TENNESSEE VALLEY AUTHORITY

By letter dated May 30, 1985, the NRC requested information related to the Black and Veatch Independent Design Verification Program at Watts Bar Nuclear Plant. The enclosure to that letter consisted of five questions. The purpose of this letter is to provide a response to those five items.

ENCLOSURE
WATTS BAR NUCLEAR PLANT
RESPONSE TO QUESTIONS OF THE MAY 30, 1985,
NRC REQUEST FOR ADDITIONAL INFORMATION
ON THE BLACK AND VEATCH INDEPENDENT REVIEW

Figure 2

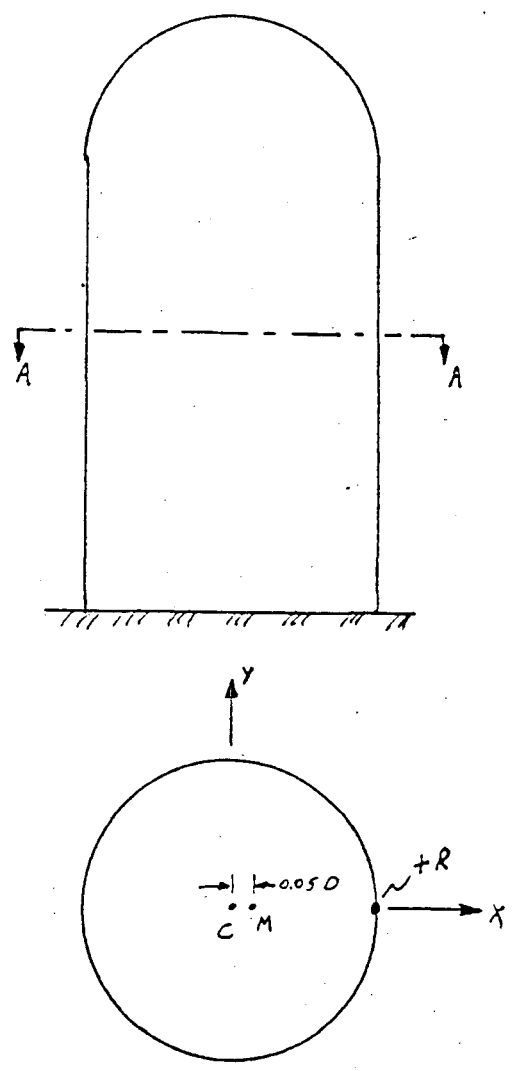
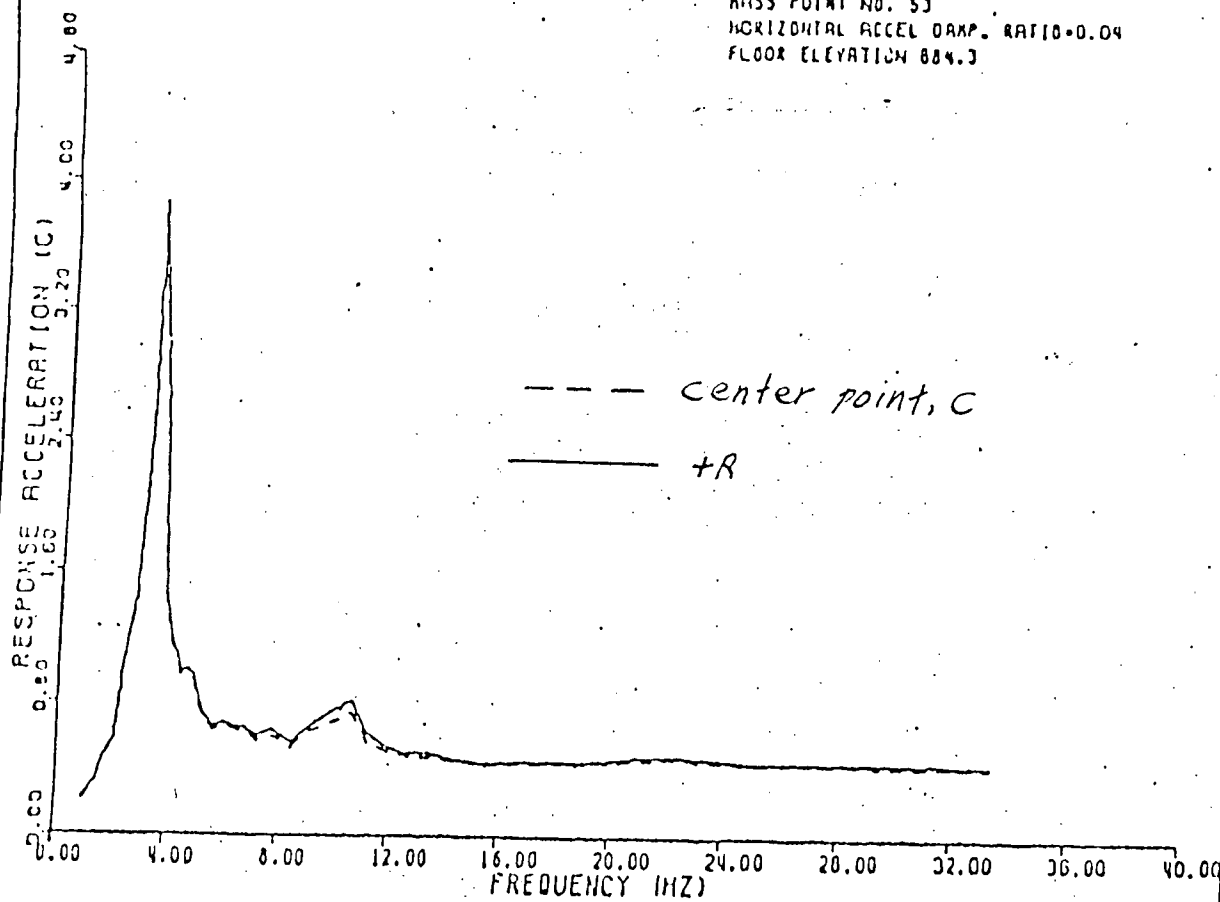
In those instances where TVA has used 5-percent eccentricity on cylindrical structures, the effect has been shown to be small. One way of expressing the effect of including the 5-percent eccentricity is to compare the motion of a point on the shell (shown as "+R" in section A-A, figure 1) to the motion of the center of the cylinder, C. If the torsional effects are significant, the motion of these two points will be significantly different. Figure 2 is a response spectrum plot of these two points for the seismic

analysis of the Bellefonte Nuclear Plant secondary containment structure. (It is a plot of the peak acceleration of subsystems of various frequencies attached to the structure.) Since the two points have almost identical response spectra, the effect of considering the 5-percent eccentricity is seen to be small.

PROJECT WBNP CONTRACT 74C38-33015
DRAWING # 03B-1AFW-R188
SHEET 112 REV 904 UNIT 1

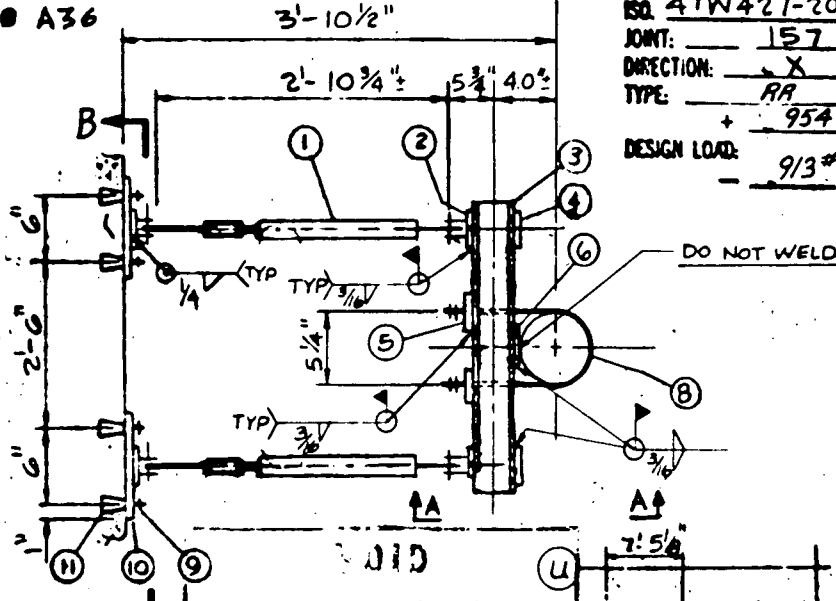
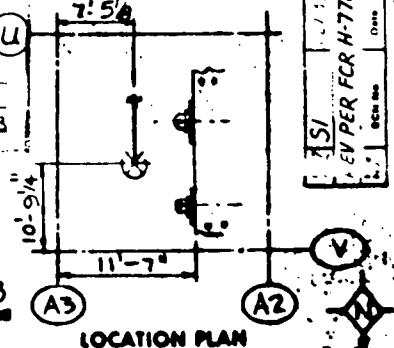
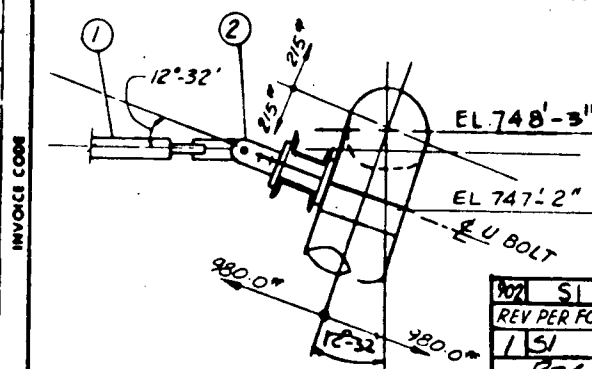
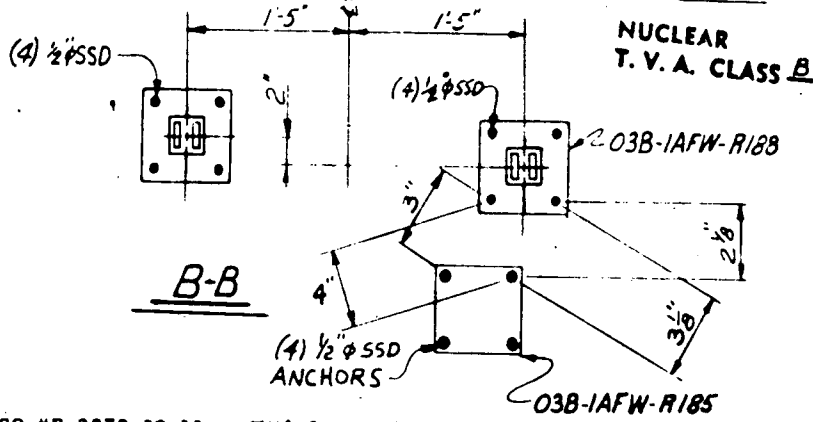
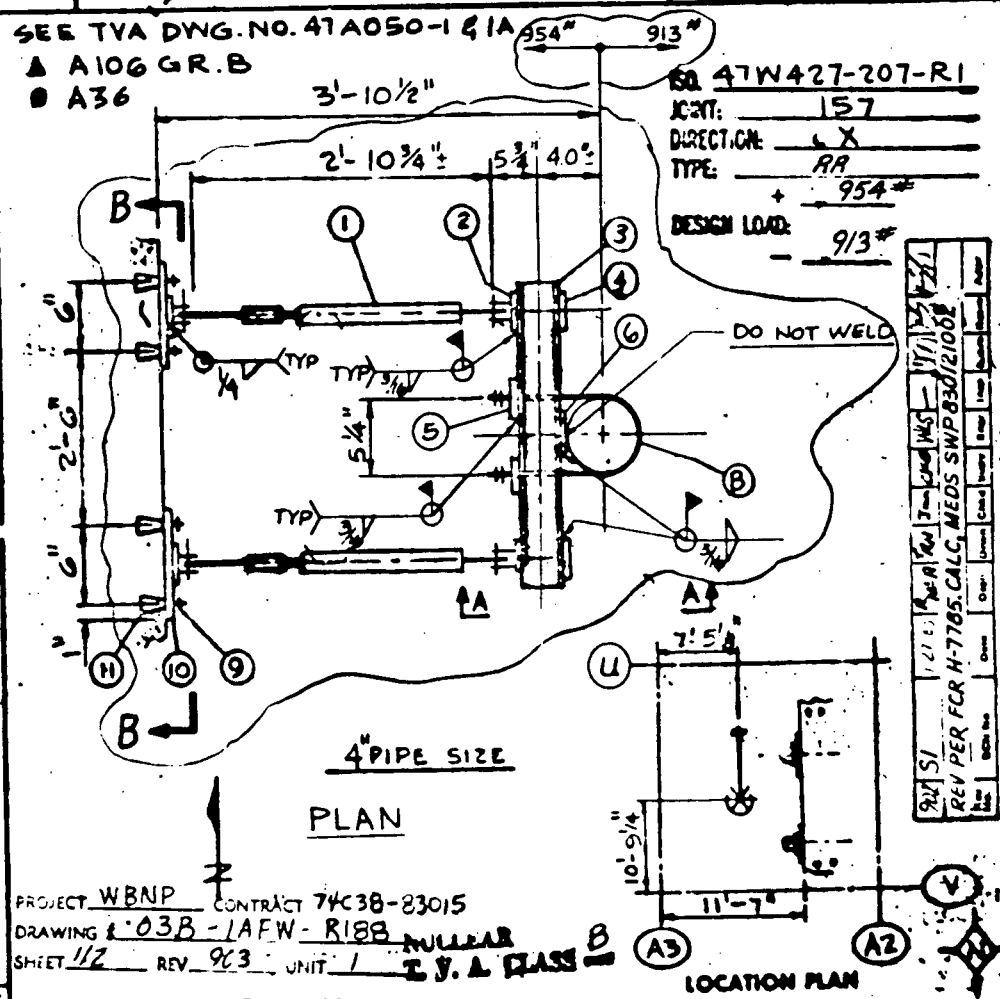
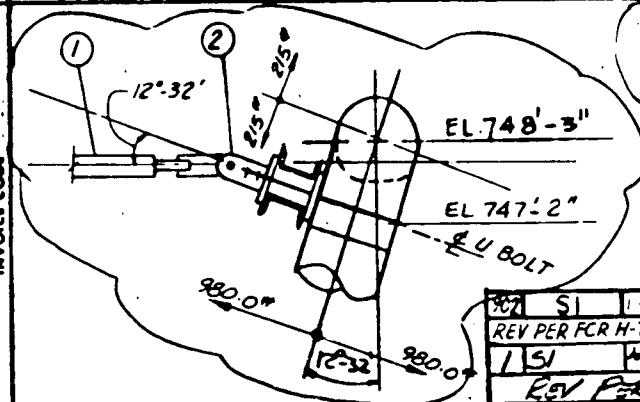
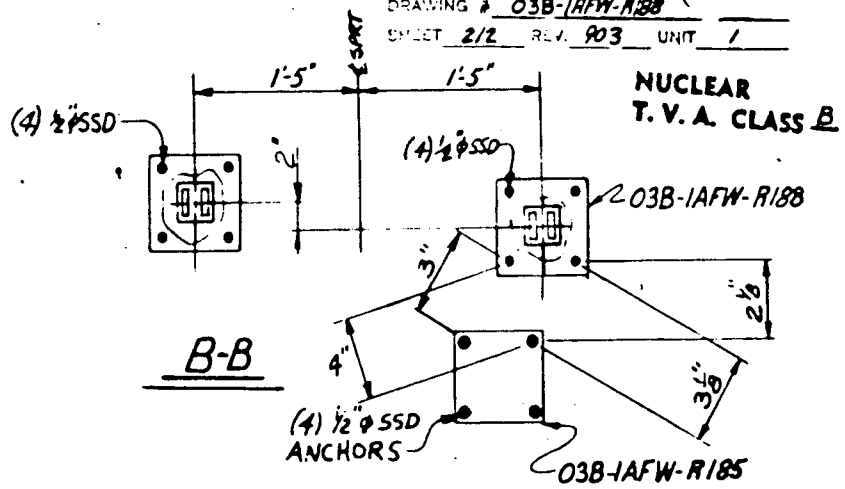
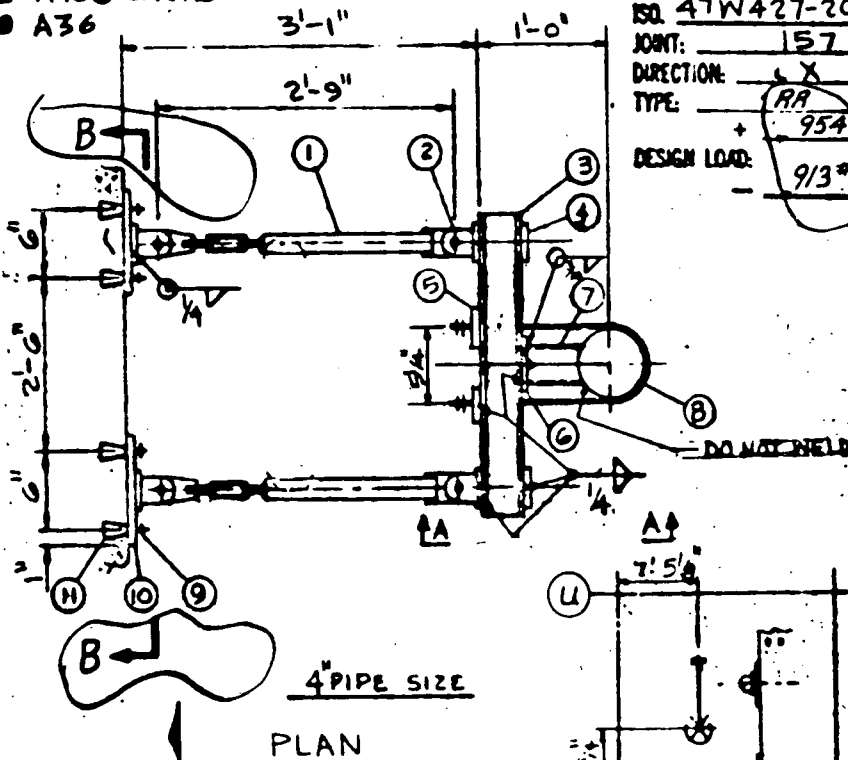
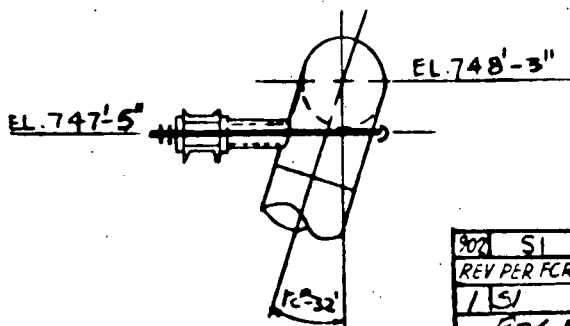
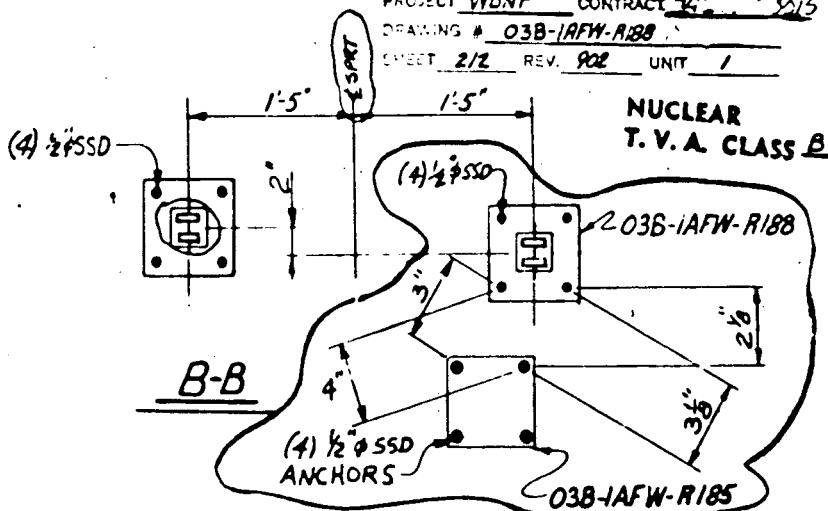
Reason UNSTABLE STRUCTURE
Superseded By 47A427-4-5
Supervisor [Signature] Date 8/1/83

VOID
UNSTABLE STRUCTURE
By 47A427-4-5

903 3511
REV PER ECN, MCR WBNWP 8305 & 80V F. 775

904 3511 11/78
 VOID DWG
 903 3511 11/78
 REV PER ECN. NCR WBNP83015 & BAVE 775

Figure 1
 Typical Arrangement Of
 Insulated Power Cables
 Coated With Flamemastic 77

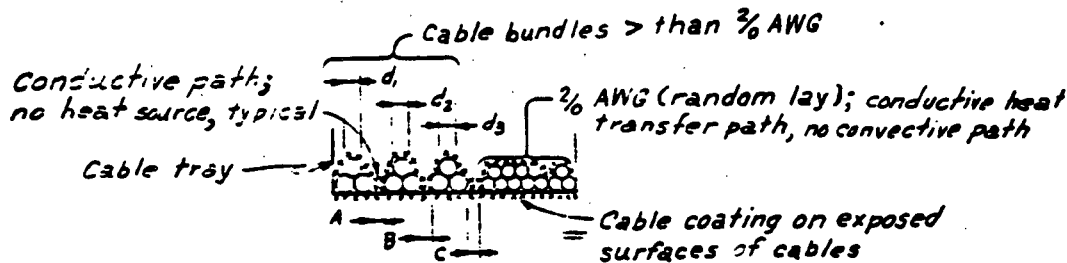
Where cable coating is required to meet fire protection requirements, it is TVA practice to coat exposed surfaces of cables including the spaces between bundles of shielded power cables. The coating is applied to a nominal 3/16-inch + 1/16-inch wet thickness. With reference to Detail B of Figure 1, it should be noted that the coating itself between cable bundles is not a heat source; instead the coating is an excellent conductor of heat, based on independent laboratory tests.

Testing performed for Vimasco by the Factory Mutual Research (FM) (Report No. J.I. OFQ05.AF) concluded that with two wet coat thicknesses of 1/8-inch each (1/4-inch maximum thickness which is upper limit of TVA design), applied sequentially between tests, the ampacity decreased only by 1.62

percent, which TVA considers insignificant. The FM tests were performed on power cables arranged in cable trays, uniformly stacked three cables deep, as shown in Detail A of Figure 1. The intent of the cable arrangement was to simulate a 40 percent tray fill (the actual fill was 43 percent) and to have all cables (except the ones located in the corners of the tray) touch other cables on at least three sides. This arrangement essentially eliminates air paths (convection) between the conductors and causes an opposite effect in that there is one heat source surrounded by other adjacent heat sources. For this reason, the tests as performed represent a worst case situation. The 2/0 AWG cables shown in Detail B of Figure 1, represent the same configuration as that tested, in that cables touch each other. The majority of the cables are 2/0 AWG for 6.9-kV service. Again, the coated 3-cable bundles do not touch, except as described above, and the coating provides a conductive path for heat dissipation. Furthermore, the test shows the heat transfer between the tightly packed cables coated with Vimasco and air paths is so good that the coating need not be considered in the design of the cable system.

A study (EEB 840203 901) was performed which showed that adequate ampacity exists for cables after derating for the cable coating. Therefore, the licensing bases is satisfied.

Figure 1
Typical Arrangement Of
Insulated Power Cables
Coated With Vimasco 2-B

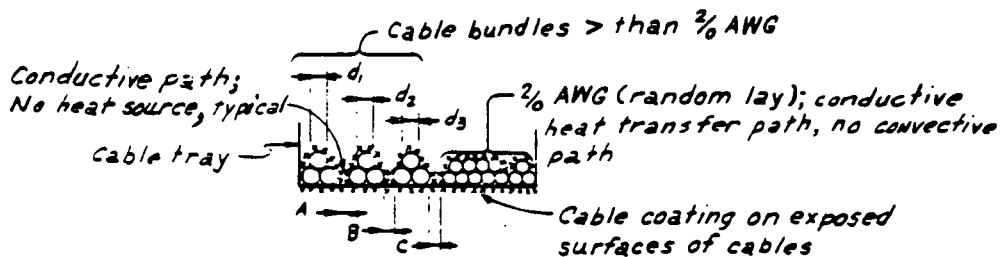
Where cable coating is required to meet fire protection requirements, it is TVA practice to coat exposed surfaces of cables including the spaces between bundles of shielded power cables. The coating is applied to a nominal 3/16-inch ± 1/16-inch wet thickness. With reference to Detail B of Figure 1, it should be noted that the coating itself between cable bundles is not a heat source; instead the coating is an excellent conductor of heat, based on independent laboratory tests.

percent, which TVA considers insignificant. The FM tests were performed on power cables arranged in cable trays, uniformly stacked three cables deep, as shown in Detail A of Figure 1. The intent of the cable arrangement was to simulate a 40 percent tray fill (the actual fill was 43 percent) and to have all cables (except the ones located in the corners of the tray) touch other cables on at least three sides. This arrangement essentially eliminates air paths (convection) between the conductors and causes an opposite effect in that there is one heat source surrounded by other adjacent heat sources. For this reason, the tests as performed represent a worst case situation. The 2/0 AWG cables shown in Detail B of Figure 1, represent the same configuration as that tested, in that cables touch each other. The majority of the cables are 2/0 AWG for 6.9-kV service. Again, the coated 3-cable bundles do not touch, except as described above, and the coating provides a conductive path for heat dissipation. Furthermore, the test shows the heat transfer between the tightly packed cables coated with Vimasco and air paths is so good that the coating need not be considered in the design of the cable system.

Figure 1

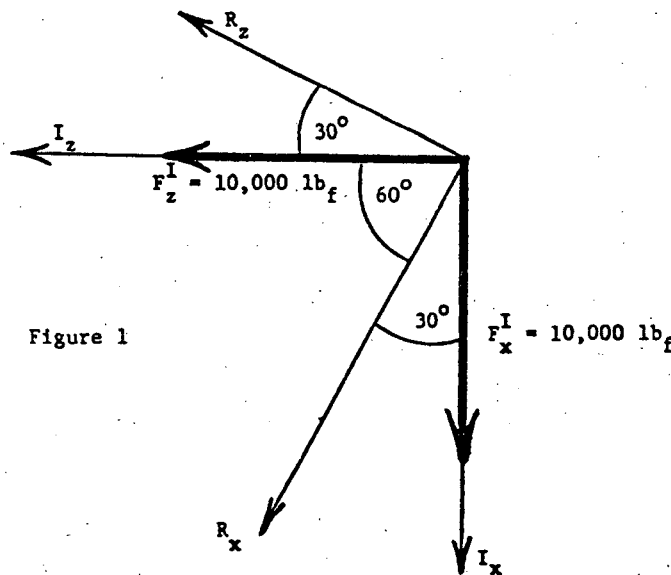
Discrepancies have been found in the input specifications for the direction cosines option of the ANCHOR program. The output could also have been misinterpreted in the wrong coordinate system. This option only affects anchors that are skewed relative to the plant global coordinate system.

This subtle difference can best be illustrated with an example. Consider a 10,000 lb_f load in the x and z directions of the input (I) system as shown in figure 1. If the record (R) system is skewed 30° from the input system as shown (common Y_I = Y_R up out of page), it can be shown that these loads resolve into the record system as:
